Brownsburg Community School Corporation  
**White Lick ES Central Plant Equipment Installation**

DATE: March 13, 2023

This Addendum issued prior to bidding, alters, amends, corrects or clarifies the Proposal Documents to the extent stated herein and does hereby become a part of the Proposal Documents, and will become a part of the Contract Documents of the successful bidder.

SHEET NUMBER:  
**E301**

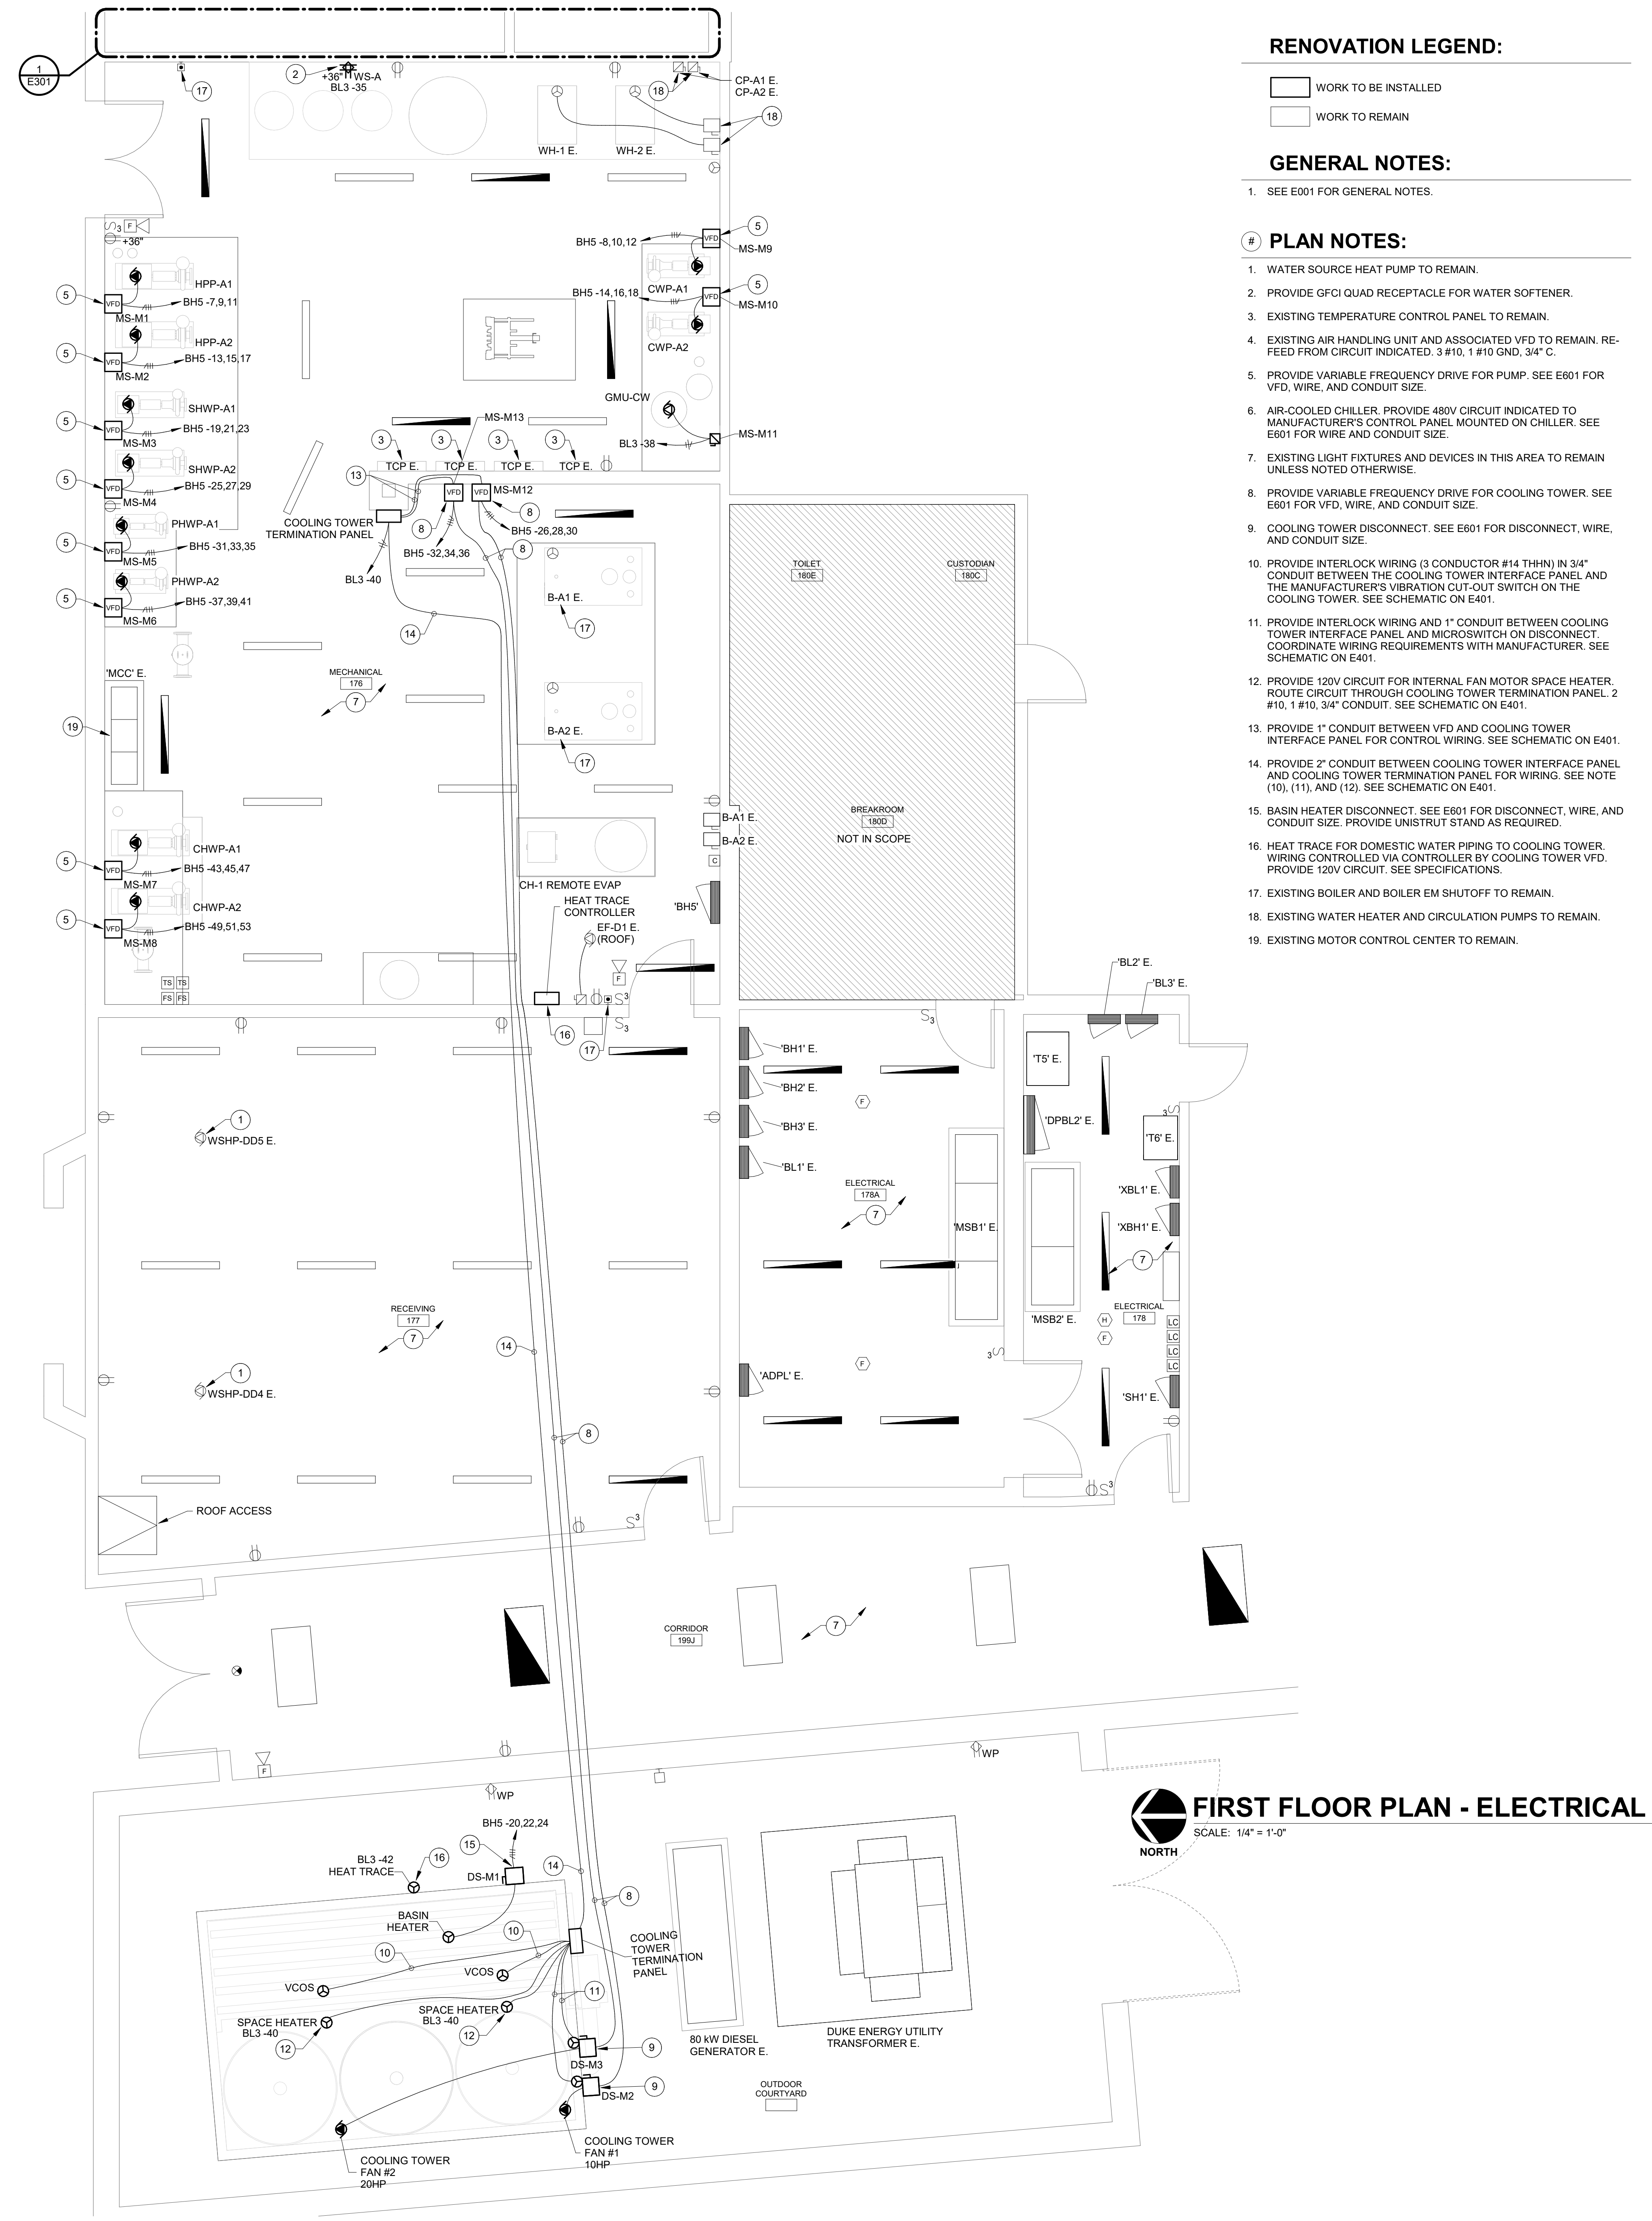
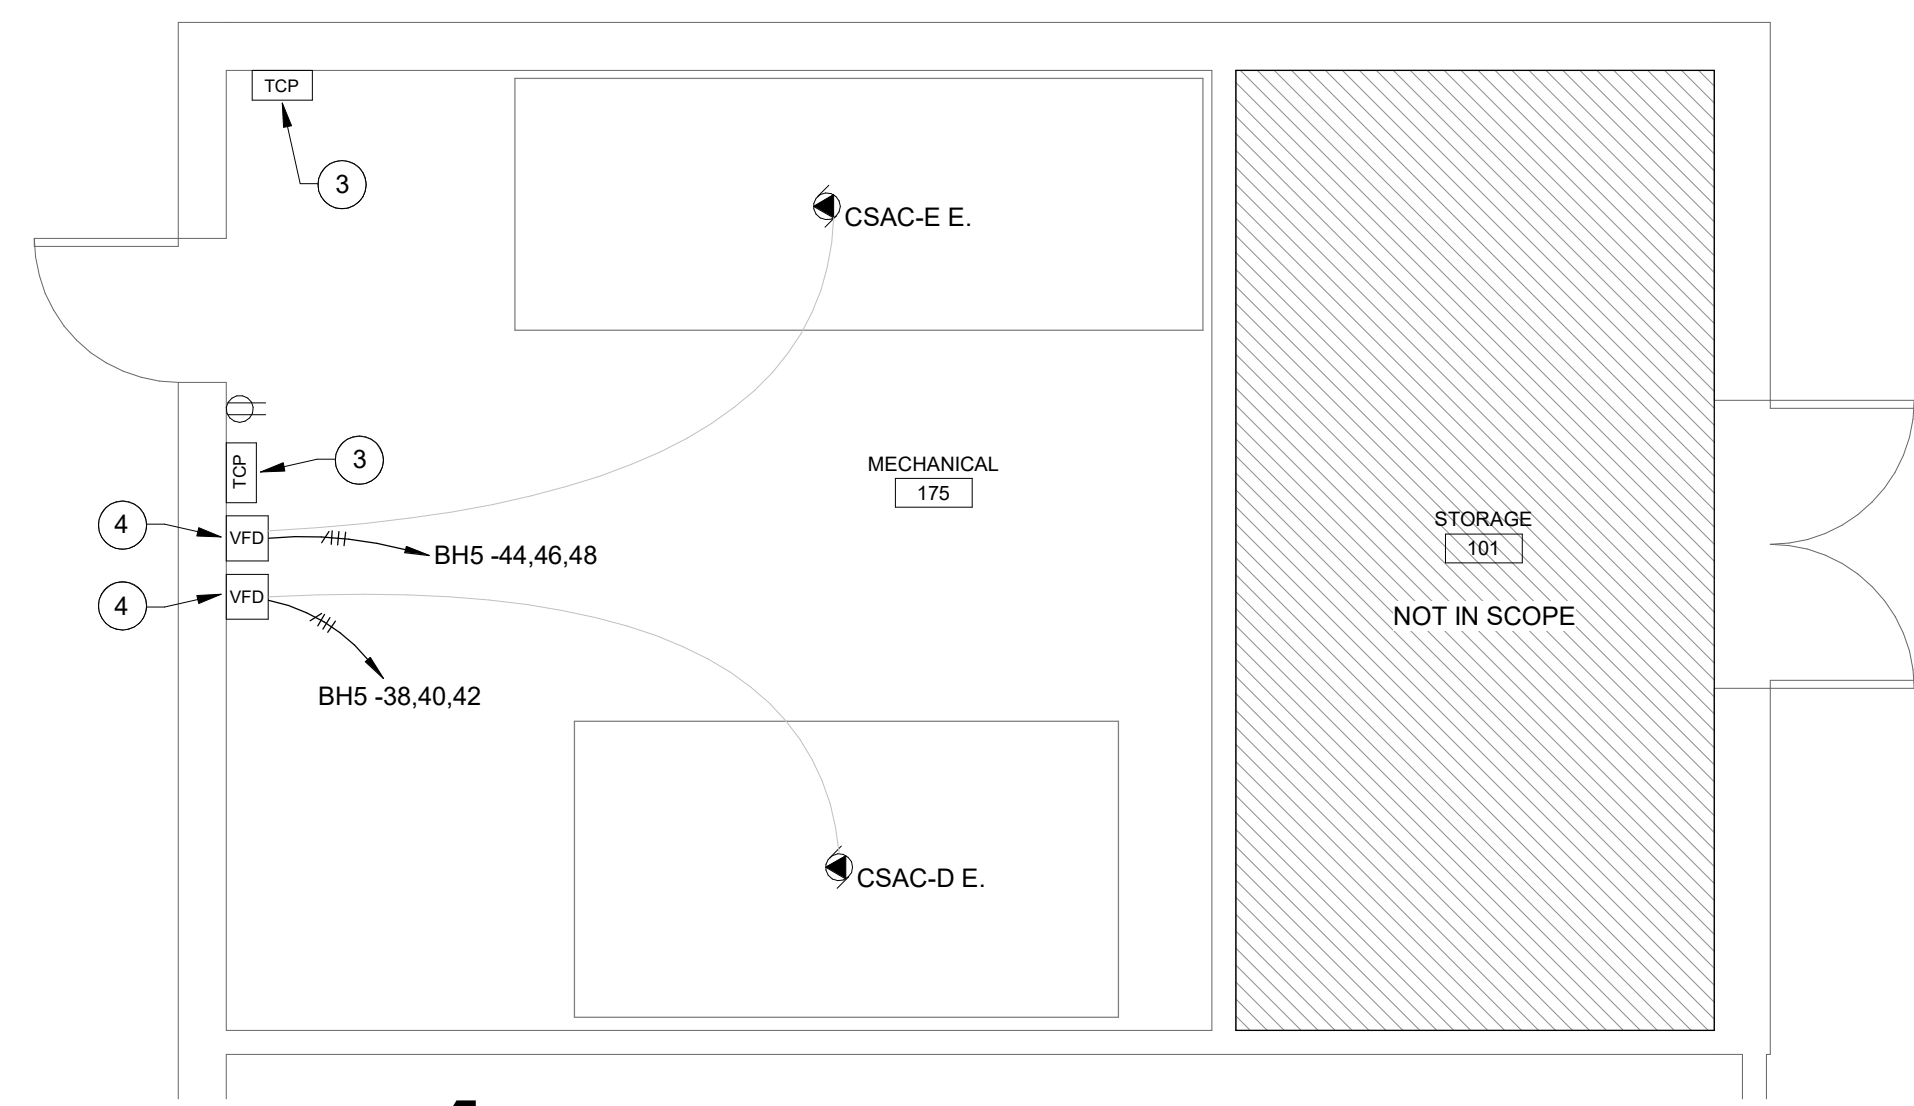
1. Drawing E301 – Mechanical Room Plan - Electrical
  - a. Revise Chiller location and extend electrical branch circuit as indicated.
